Access Compliance Report

Public Rights-of-Way

Intersection ID: 12519	Main Street: E_6TH_ST	Cross Street: N_CALDWELL_ST	Location: W
ADA ID: 78B339EB8FDD	Ramp Type: PerpDiag	Initial Pass/Fail: Fail	Overall Compliance: No
			Severity Score: 26.25

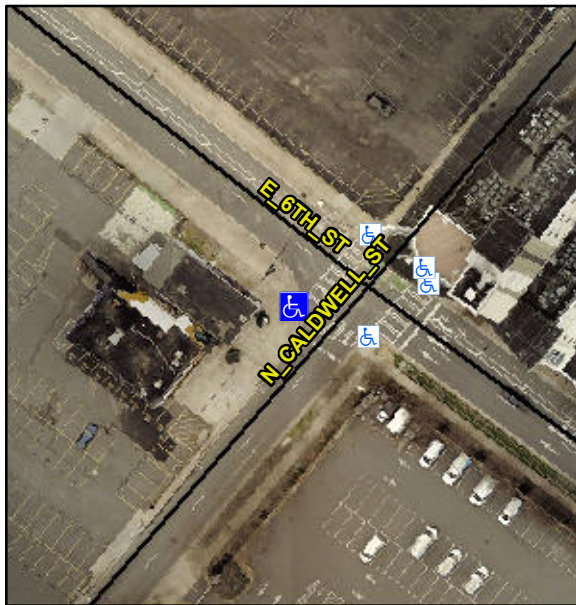
Not Found, R304.2.2, R304.5.3

Compliance	Description	Data	Compliance	Description	Data
N/A	Ramp Length (in)	61.0	No	Ramp Slope (%)	12.9
Yes	Ramp Width (in)	50.0	No	Ramp XSlope (%)	3.9
N/A	Flare Type LT	N/A	N/A	Flare Type RT	N/A
N/A	Flare Slope LT (%)	N/A	N/A	Flare Slope RT (%)	N/A
N/A	Flare Traversable LT?	N/A	N/A	Flare Traversable RT?	N/A
N/A	Landing Length (in)	N/A	N/A	DWS Provided?	N/A
N/A	Landing Width (in)	N/A	N/A	DWS Contrast?	N/A
N/A	Landing Slope (%)	N/A	N/A	DWS Length (in)	N/A
N/A	Landing X Slope (%)	N/A	N/A	DWS Full Width?	N/A
N/A	Landing Curb? (Y/N)	N/A	N/A	DWS Offset (in)	N/A
N/A	Shared Landing?	N/A			
N/A	Gutter Ponding?	N/A	N/A	Gutter Slope (%)	N/A
N/A	Gutter Lip Ht (in)	0.5	N/A	Gutter X Slope (%)	N/A
N/A	Painted X Walk1?	Yes	N/A	Painted X Walk2?	Yes
	X Walk 1 Direction	To SE		X Walk 2 Direction	To NE
N/A	X Walk 1 Width (in)	100.0	N/A	X Walk 2 Width (in)	102.0
	X Walk 1 Slope (%)	2.5		X Walk 2 Slope (%)	3.7
	X Walk 1 X Slope (%)	1.8		X Walk 2 X Slope (%)	1.4

Remove & Replace Curb Ramp With Two New Directional Ramps or Equivalent.
